AFE using MCP6002 op-amp - Design #5 #63

Here's a super simple analog front end that uses the (cheap and available) MCP6002 R-to-R dual op-amp. This particular design uses one of the amps (and channels) for a $\pm 7V$ input range and the other for a $\pm 1V$ range. The design also incorporates under/overvoltage protection.

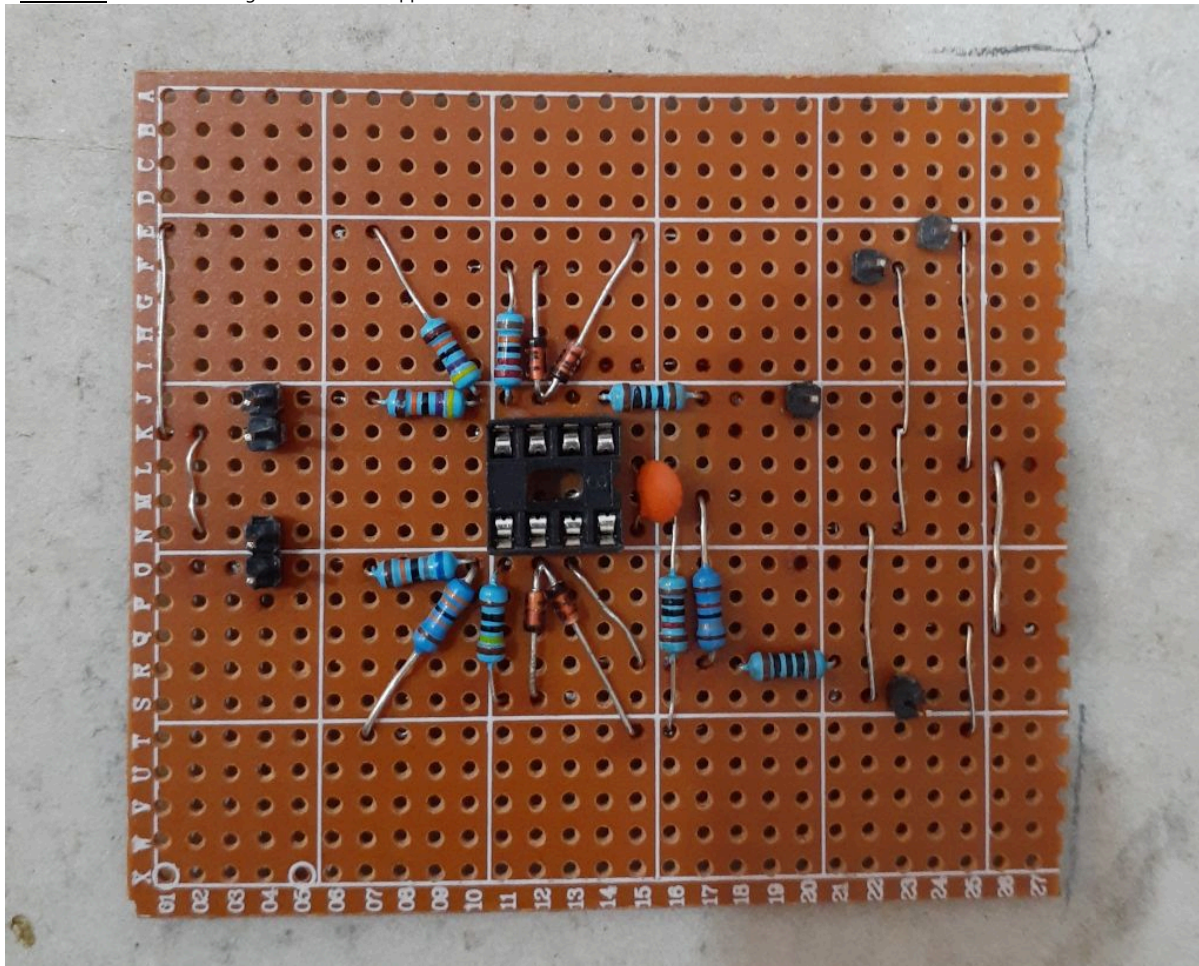
Hi FHDM-dev, I just ordered the MCP6292 and Rpu - I saw you pointed out for Design 1 how to change the resistors for 10x probes. Could you kindly point out for me, what I would need to change with this design? Many thanks for your awesome work!

That makes sense, though I think you should ignore the fact that there is a +/- 7V range on the schematic. You can choose whatever range you like and calculate the appropriate resistor values for that. Once you've entered the actual voltage range into the app it will show the correct value (ie. you don't need to wrongly configure it and you don't need to change the probe attenuation settings in the app). And for all the ranges you can choose to use either 10X or 1X probes when calculating the resistor values - you just can't switch between them.

approx. +/- 70V range using 10X probes:

R1_1=470k

R2_1=470k

RX_1=470k

Actual Input Range Min=-66.5V

Actual Input Range Max=+69.8V

+/- 70V range using 1X probes:

R1_1=1000k

R2_1=47k

RX_1=47k

Actual Input Range Min=-70.2V

Actual Input Range Max=+73.5V

All I do know is that applying 18+V to the input of the MCP6292 without limiting the current will destroy it. I learnt that the hard way 😬

So I would make sure that the attenuation and overvoltage protection is working correctly before attaching the MCP6292. That is, the voltage at the inputs of the op-amp shouldn't ever go below -1V or above 4.3V.
